Department of Energy

August 13, 2009

YUCCA MOUNTAIN – REQUEST FOR ADDITIONAL INFORMATION – VOLUME 2,
CHAPTER 2.1.1.2, SET 2 (DEPARTMENT OF ENERGY'S SAFETY ANALYSIS REPORT
SECTIONS 1.2.2, 1.2.8, 1.3.3, 1.4.1, 1.4.2 and 1.4.3) – Description of Systems, Structures and
Components

Figure 1. Subsurface Facility Typical Inflow Airflow Allocation in Network Model

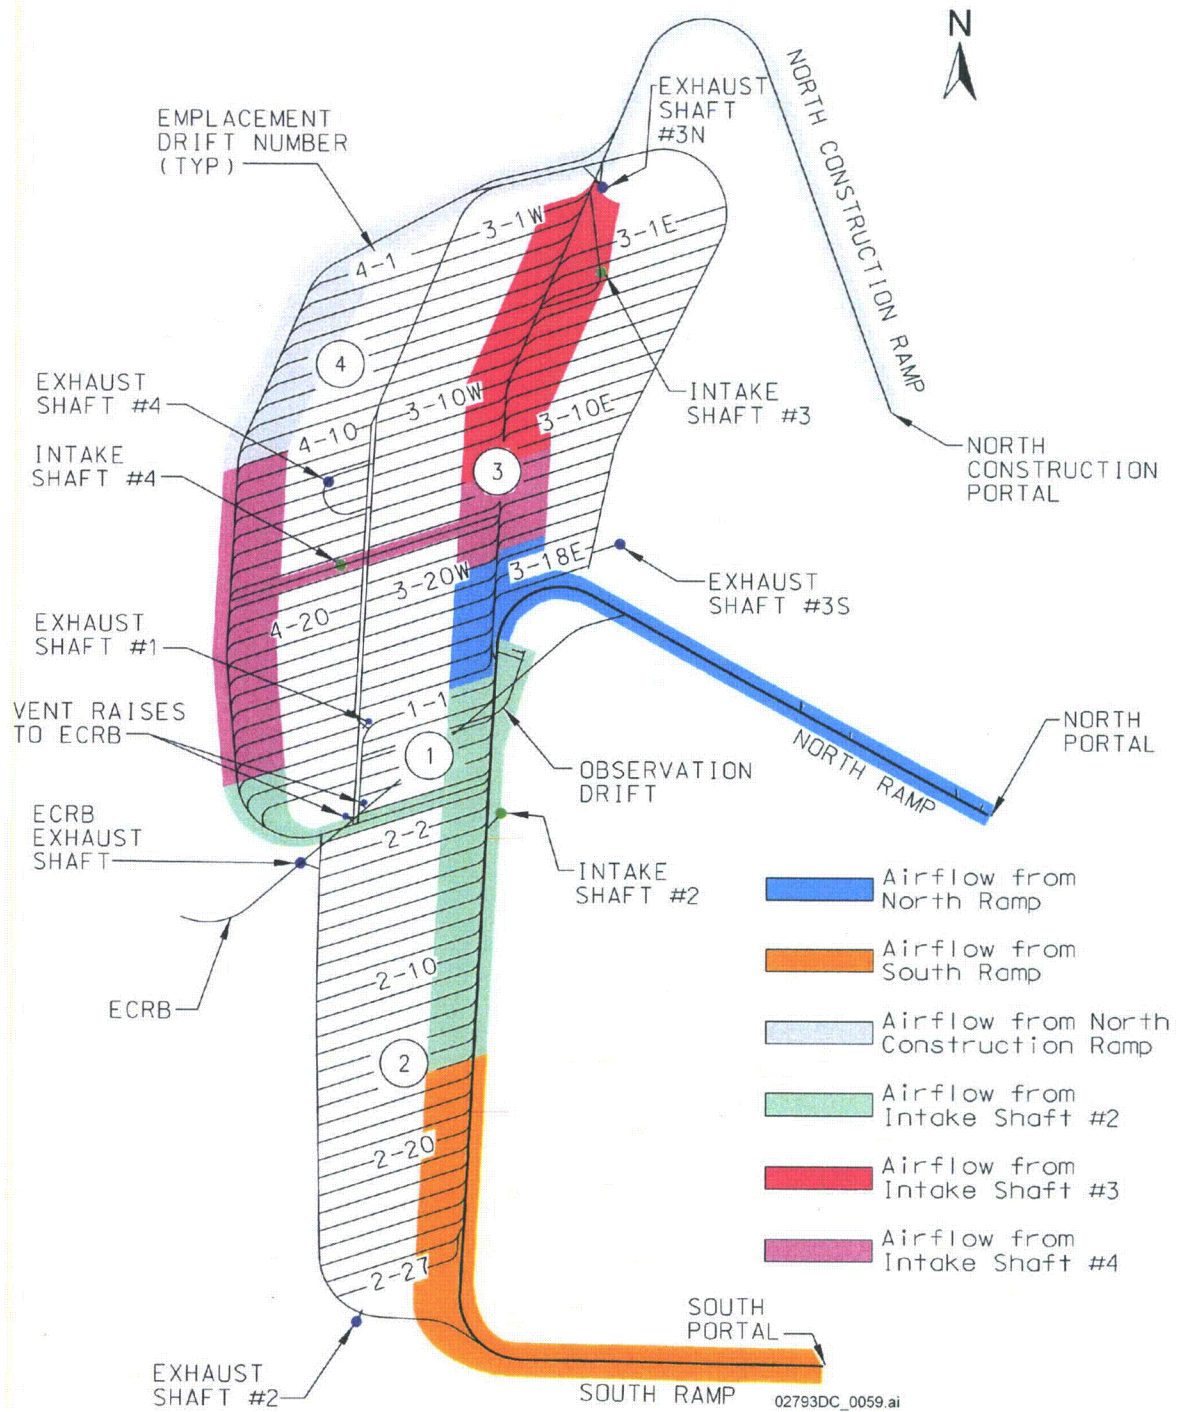
- a) Technical Basis for 900 hp exhaust fans for the subsurface facility representing 70 percent of the required air volume for the emplacement drifts. This information is needed to verify DOE's statement (SAR Section 1.3.5.1.3.1) that a 900 hp exhaust fan can provide 70 percent of the required air volume for the emplacement drifts.
- b) Standards and codes used for the interfaces between the mobile diesel backup power generators and the fans, variable speed drives, etc.
- c) Capacity of each of the standby diesel generators. This information is needed to verify that three of the four generators have sufficient power to perform their safety functions (SAR Section 1.4.1.1.1.3).

Figure 2. Isometric View of Areas in Panels 1, 3, and 4 with Parallel Exhaust Mains

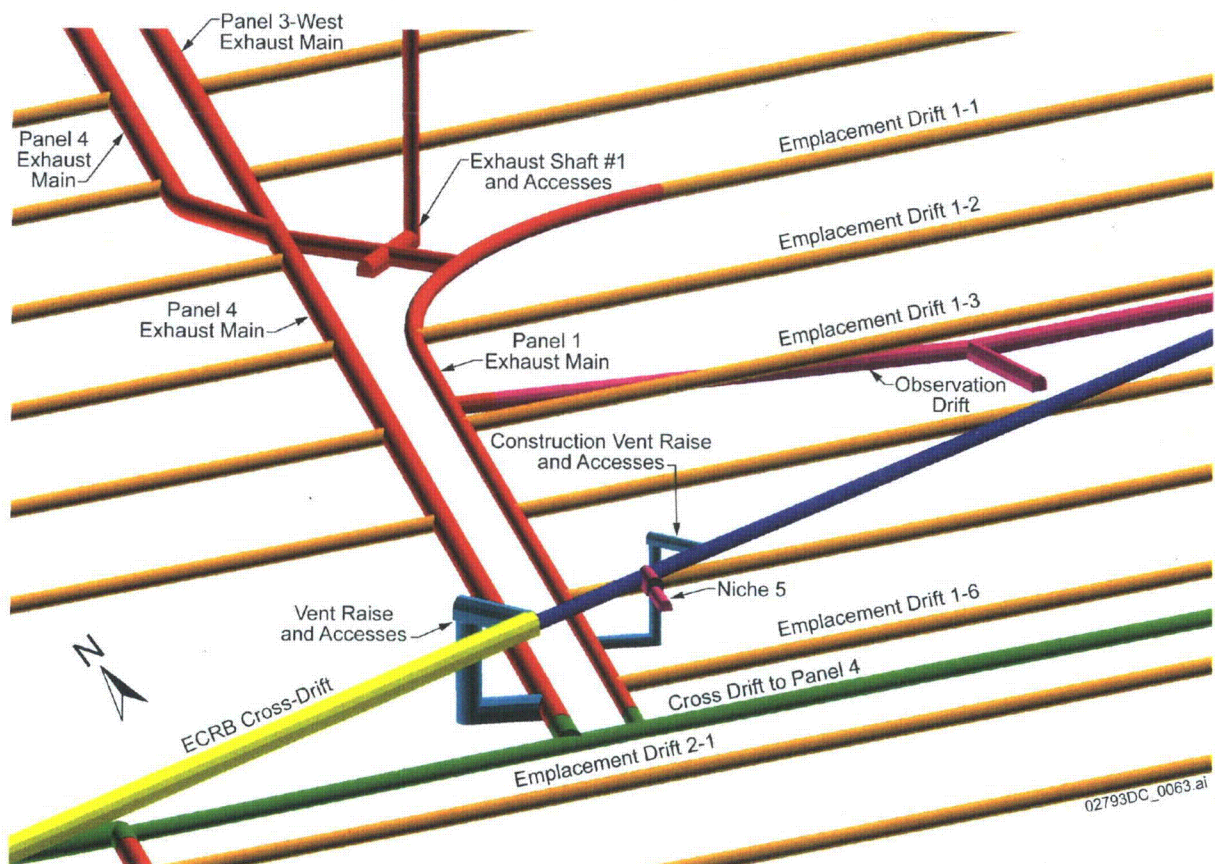
Describe the geometrical relationships between the exhaust main for emplacement drift Panel 4 and the exhaust mains for Panel 1 and Panel 3-west, sufficient to show the shape and dimensions of the rock pillar between the exhaust mains.

In SAR Section 1.3.3.1.3 and Figure 1.3.3-8, DOE indicates that emplacement drift Panels 4, 3-west, and 1 have separate but closely spaced exhaust mains. The applicant explained that separate exhaust mains are needed to allow concurrent development in Panel 4 and waste emplacement in Panel 3-west or development in Panel 4 adjacent to a waste-loaded Panel 1. DOE, however, has not described the geometrical arrangement of openings in this area in detail.

Figure 2 is an isometric illustration that depicts the geometric arrangement of the parallel exhaust main openings (shown in red in the center of the figure) in the Panels 1, 3-West, and 4 areas. This figure also illustrates that the Panel 3-West and Panel 4 exhaust mains intersect near exhaust shaft #1.
